Subject: FW: Urban Design testing of HOB and FSR - RR-2023-12 - 407-511 King Georges Road, Beverly Hills

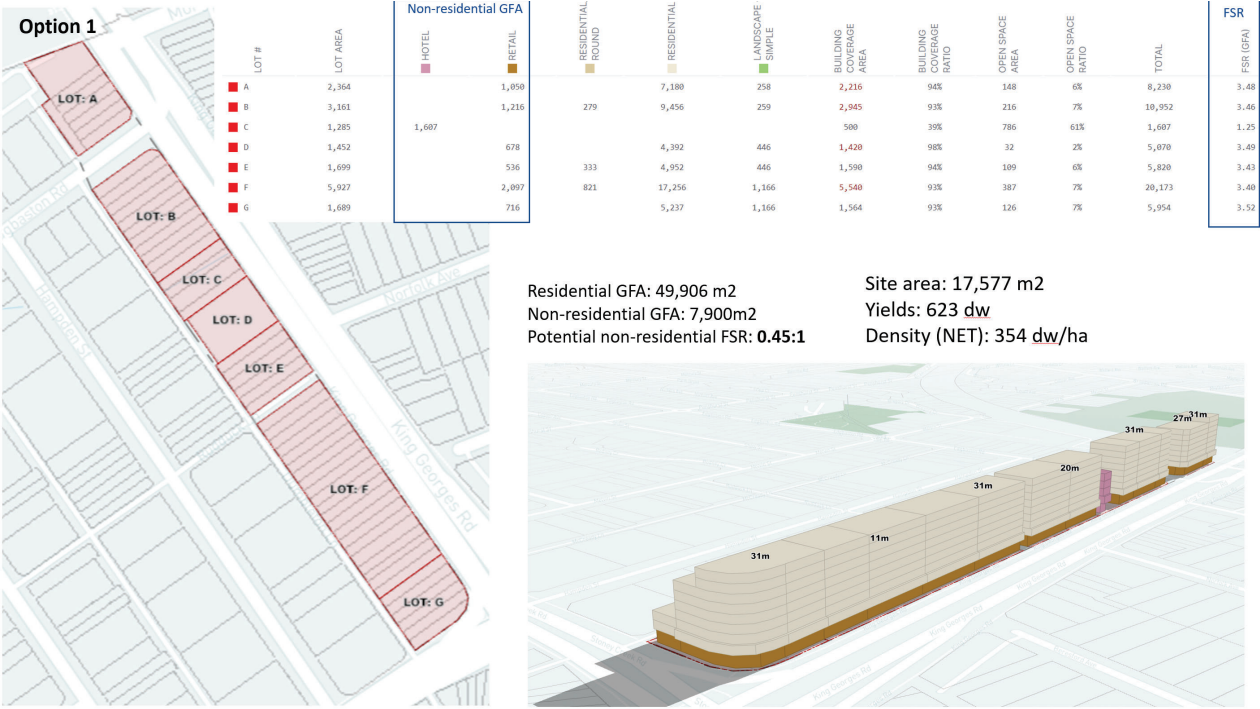
**Option 1** – Maintain the Panel’s 3.5:1 FSR across the precinct to understand the achievable maximum HOB. In this option, the height of the buildings will be up to 9 storeys along King Georges Road and 3 storeys along Dumbleton Lane. The non-residential FSR for both options remain the same at 0.45:1 (less than the Panel’s requested 0.75:1). To achieve the additional non-residential FSR of 0.3:1, about 70% of the first floor along King Georges Road needs to change from residential to non-residential if feasible.

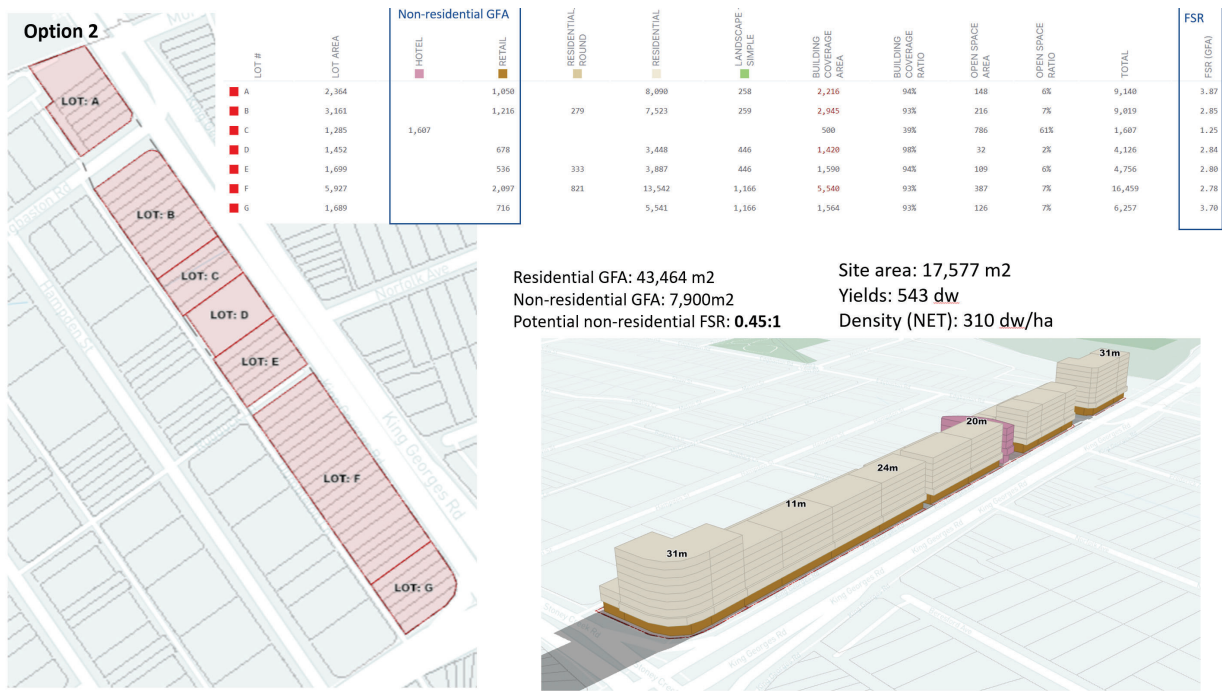
**Option 2** (I shared this option in the previous email) – Maintain the Panel’s heights and split the area into sections to calculate the achievable maximum FSR. In these tables, as I have marked up, you can see the non-residential GFAs in each LOT boundary.

Across two options please note, the FSR of 1.25:1 for LOT C is the approved DA for the new hotel. I did not increase the controls for this development. The current DA has an FSR of 1.25:1 and 5 storeys (1,607 m<sup>2</sup> non-residential GFA). If the proponent requests to increase the HOB to 7 storeys, the GFA will increase to 2,400 m<sup>2</sup>. However, the height will exceed 24m, as the floor-to-floor height for hotel uses is higher than for residential uses (3.8m f/f vs 3.2m for residential).
